# PRODUCT CHANGE NOTIFICATION

## Bourns® SRP4018FA, SRP4020FA, SRP4030FA, SRP4020CA and SRP4030CA Series Shielded Power Inductors

### *Change in T-core Design*

IC25006

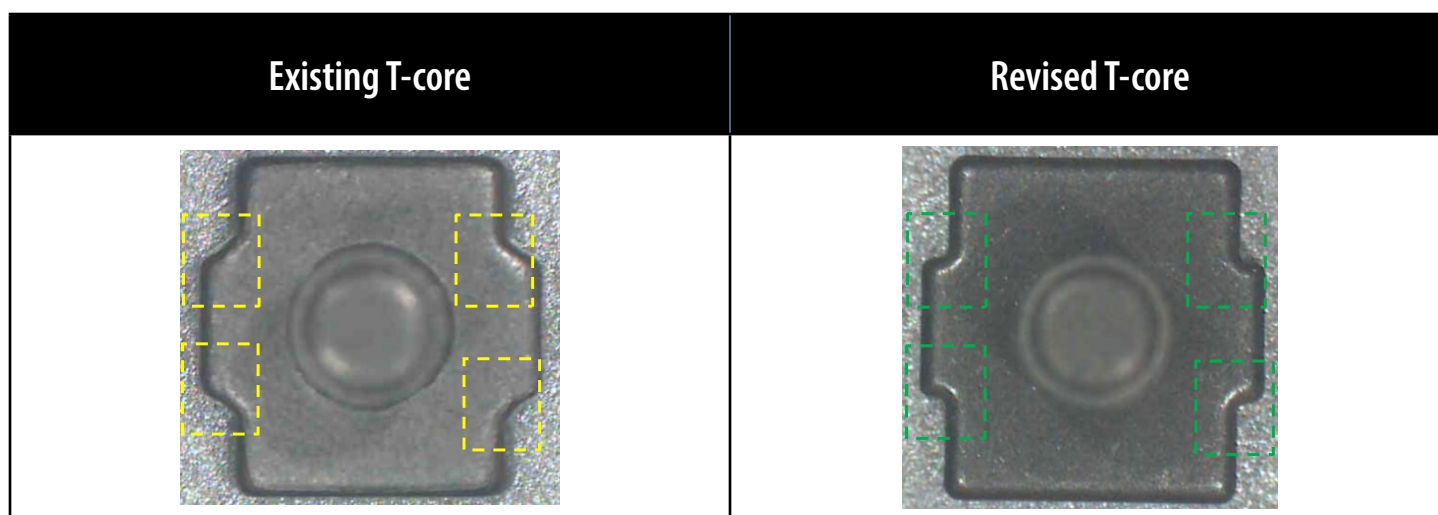
Riverside, California – February 18, 2025 – As part of our continuous improvement efforts, effective October 27, 2025, Bourns will change the T-core design for the [SRP4018FA](#), [SRP4020FA](#), [SRP4030FA](#), SRP4020CA and SRP4030CA Series Shielded Power Inductors. The copper wire joint of the T-core will have a slightly more right-angled shape to enhance structural stability. A list of affected part numbers is included below.

The form, fit, and function of the finished products will remain the same. The quality and reliability of the inductors should be improved. Traceability will be maintained through lot code and date code.
